Product Change Notification

PCN #: 5C-2018

DATE: 10th May 2018

The BL652 Series of modules and associated development kits utilise the Nordic Semiconductor nRF52832-QFAA silicon. Starting from the **Build Code 1820** listed on each module's individual product label, Laird will be utilising the new E00 revision of the Nordic nRF52832-QFAA silicon inside the module.

Figure 1: Module label

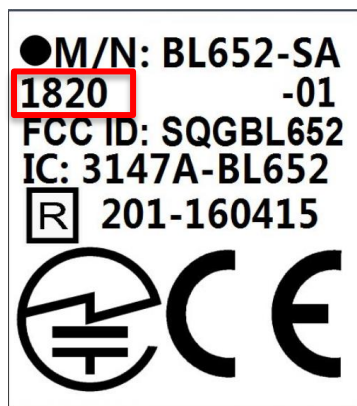
The change can be identified by reviewing the **Build Code** number that is present on the individual module, reel label and carton label. The images below identify where this **Build Code** is located on each of those labels.

A Build Code that starts with **1820**, and all subsequent incremental numbers, indicates that the nRF5283-QFAA-E00 silicon is utilised.
